# UNITED STATES PATENT AND TRADEMARK OFFICE

| APPLICATION NO.                      | FILING DATE | FIRST NAMED INVENTOR       | ATTORNEY DOCKET NO. | CONFIRMATION NO. |
|--------------------------------------|-------------|----------------------------|---------------------|------------------|
| 10/720,752                           | 11/25/2003  | Emiel Jozef Melanie Eussen | 081468-0306993      | 2765             |

| <b>Office Action Summary</b> | Application No. | Applicant(s)  |

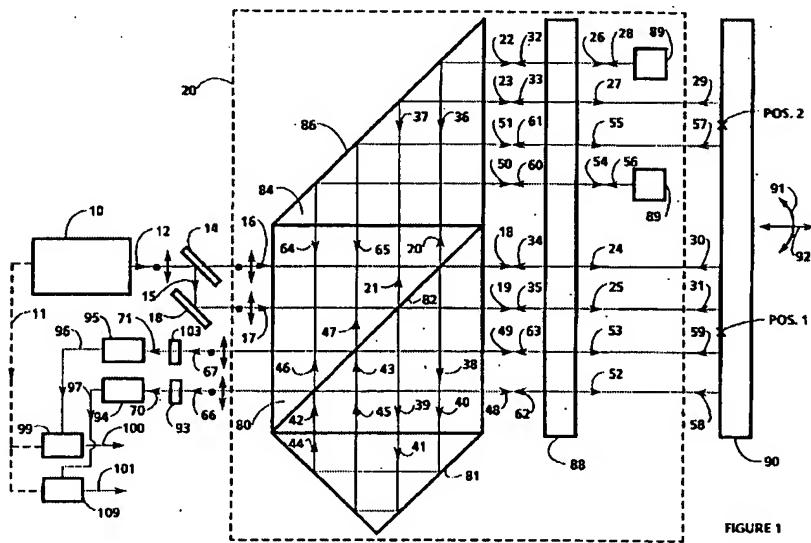
With regard to claim 1, Sommargren teaches an interferometer system(20) for measuring displacement, along at least two directions within a three dimensional system of coordinates, of an object in a plane substantially parallel to a two dimensional plane, said interferometer system comprising:

a plane mirror interferometer system(14,80,81,84,89,90);  
a differential plane mirror interferometer system(18,80,81,84, 90); and  
a beam splitter arrangement(80) configured to split a radiation beam(16)  
associated with said plane mirror interferometer system and a radiation beam(17)  
associated with said differential plane mirror interferometer system into respective  
measuring beams(18,19) and respective reference beams(20,21).

As to claim 2, wherein said beam-splitter arrangement includes a  
transparent body(80) having a beam-splitting surface(82) and a first reflector(84)  
which is integrally connected to said transparent body and which has a reflective  
surface(86) that extends substantially parallel to the beam splitting surface.

With regard to claim 3, Sommargren teaches an interferometer system(20)  
for measuring displacement along at least two directions in an XYZ system of co-  
ordinates, of an object in a plane substantially parallel to an XY plane, said  
interferometer system comprising:

at least one measuring mirror(90) fixedly connected to said object and  
comprising a plurality of measuring mirror areas;

at least one reference mirror(89) comprising at least one reference mirror  
area;

a beam generator(14,18,80,81,84) configured to generate a plurality of  
radiation beams(16,17), said beam generator comprising a beam-splitter block(80)  
having a beam splitting surface(82);

a plurality of radiation-sensitive detectors(94,95) configured to convert radiation beams(66,67) reflected towards said detectors into electric measuring signals;

wherein said beam splitter block(80) is configured to split at least one first beam(16) of said plurality of radiation beams into a first measuring beam(18) and a first reference beam(20),

said first reference beam(20) only being reflected by one or more first reference mirrors(89) located in a fixed position with respect to said beam-splitter block(80),

said first measuring beam(18) being reflected by a first measuring mirror area(at reflection 18-30) of said plurality of measuring mirror areas, and

wherein said beam splitting surface(82) is configured to split at least one second beam(17) of said plurality of radiation beams into a second measuring beam(19) and a second reference beam(21),

said second measuring beam(19) being reflected by a second measuring mirror area(at reflection 19-31) of said plurality of measuring mirror areas, and

said second reference beam(21) being reflected by a first reflector(86) that is fixedly positioned with respect to said beam-splitter block(80) and by

at least one third mirror area(at reflection 23-29), which is movable with respect to said beam-splitter block(80).

**FIG. 1**

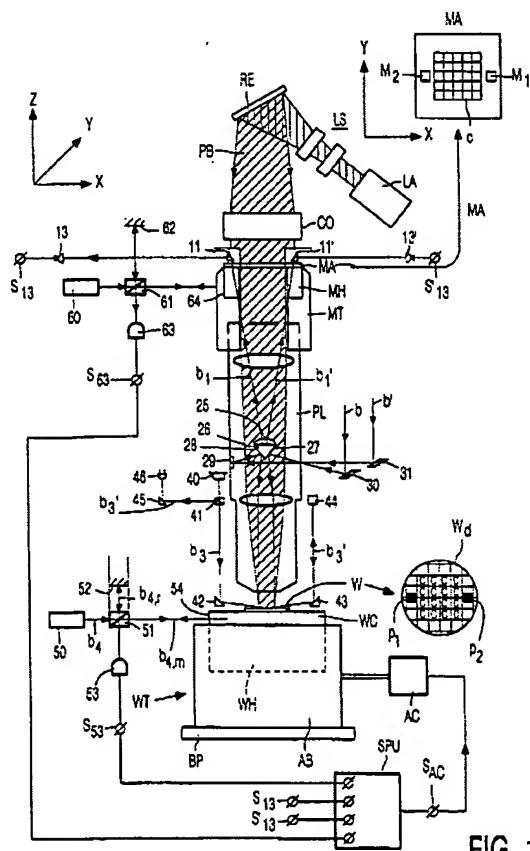
With regard to claim 18, Loopstra et al teach a device manufacturing method comprising:

providing a substrate(W);

providing a beam of radiation using an illumination system(LA);

using patterning device(MA) to impart beam of radiation with a pattern in its cross-section; and

projecting(PL) said patterned beam of radiation onto a target portion of the substrate,

wherein a position of at least one of said patterning device and said substrate is determined by an interferometer system(column 10, lines 27-46).

FIG. 11

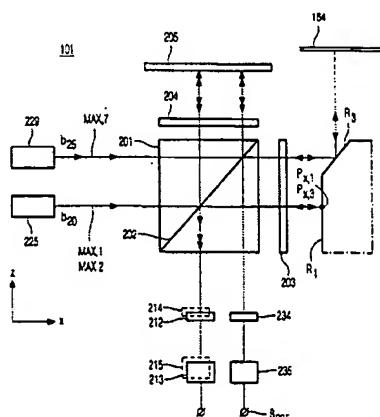
Loopstra et al teach generating a plurality of beams(figure 10-12, b<sub>20</sub>) which occupy more than one plane(figure 14, P<sub>x,1</sub>-P<sub>x,10</sub>) and a second radiation beam(figure 11, b<sub>25</sub>) in a position between two of said at least three first radiation beams(figure 14; P<sub>x,7</sub>,P<sub>x,8</sub>)

Loopstra et al teach generating a plurality of beams(figure 10-12, b<sub>20</sub>) which occupy more than one plane(figure 14, P<sub>x,1</sub>-P<sub>x,10</sub>) and a second radiation beam(figure

11, b<sub>25</sub>) in a position between two of said at least three first radiation beams(figure 14; P<sub>x,7</sub>,P<sub>x,8</sub>)

Loopstra et al teach generating a plurality of beams(figures 10-12, b<sub>20</sub>) which occupy more than one plane(figure 14, P<sub>x,1</sub>-P<sub>x,10</sub>) and a second radiation beam(figure

11, b<sub>25</sub>) in a position between two of said at least three first radiation beams(figure 14; P<sub>x,7</sub>,P<sub>x,8</sub>)

Loopstra et al teach generating a plurality of beams(figures 10-12, b<sub>20</sub>) which occupy more than one plane(figure 14, P<sub>x,1</sub>-P<sub>x,10</sub>) and a second radiation beam(figure 11, b<sub>25</sub>) in a position between two of said at least three first radiation beams(figure 14; P<sub>x,7</sub>,P<sub>x,8</sub>)
